## 4.F Alternatives

The comments and corresponding responses in this section cover topics in draft SEIR Chapter 6, Alternatives. These include topics related to:

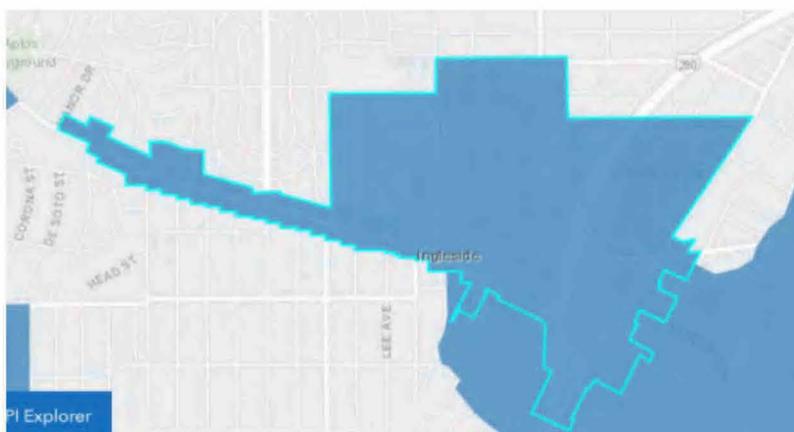
“However, I think it is deficient in its discussion of cumulative greenhouse gas emissions and traffic impacts.

In two tables (Table S-3, Table 6-6) and in the discussion of the alternatives in 6.C (p. 6-14), the EIR says that the No Project Alternative would have No Impact (NI) on greenhouse gas (GHG) emissions, whereas the proposed project would have a Less than Significant (LTS) impact on GHG emissions. Therefore, section 6.D concludes that ‘the No Project Alternative would be the environmentally superior alternative because it would result in no impacts to all resources’.

I believe this is in direct conflict with the Plan Bay Area 2040 FEIR, which finds that the ‘No Project and Main Streets Alternatives would result in a greater number of significant and unavoidable impacts compared to the proposed Plan’ of concentrating jobs and housing in Priority Development Areas (PDAs) (p. ES-8). Indeed, the whole purpose of SB 375 (2008) and Plan Bay Area was to reduce GHG emissions by concentrating jobs and housing near transit. The Plan Bay Area 2040 EIR may be used ‘as the basis for cumulative analysis of specific project impacts’ (Section 1.1.6).

This is relevant because the Balboa Reservoir is the biggest single development in the Balboa Park PDA (see screenshot of PDA map, below). It is minutes away by foot from the Balboa Park BART station and numerous Muni light rail and bus lines.

One comment states that the SEIR did not include a full analysis of greenhouse gas emissions for the No Project Alternative, which then makes it impossible to compare GHGs emissions with the proposed project options and alternatives. Analysis of potential greenhouse gas emission impacts of the proposed project is addressed in SEIR Appendix B, Initial Study, on pp. B-37 through B-40 and analysis of the alternatives is addressed in SEIR Chapter 6. As stated on page B-37 of the SEIR initial study, CEQA Guidelines section 15064.4 allows lead agencies to rely on a qualitative analysis to describe GHG emissions resulting from a project, and CEQA Guidelines section 15183.5 allows for public agencies to analyze and mitigate GHG emissions as part of a larger plan for the reduction of greenhouse gas emissions. This approach is in recognition of the fact that while no single project could generate enough GHG emissions to noticeably change the global average temperature, the combination of GHG emissions from past, present, and future projects around the world have contributed and will continue to contribute to global climate change and associated environmental impacts. Consistent with these guidelines, the initial study provides a qualitative analysis of greenhouse gas emission impacts by demonstrating the project's consistency with the City's Greenhouse Gas Reduction Strategy.

Concerning VMT and GHG emissions of the project, the SEIR determined VMT to be less than significant (SEIR pages 3.B-79 and 3.B-80) while the initial study (EIR Appendix B) identified a less-than-significant impact to GHG emissions. Accordingly, neither VMT or GHG emissions was a concern in the development of alternatives since CEQA does not require that the alternatives
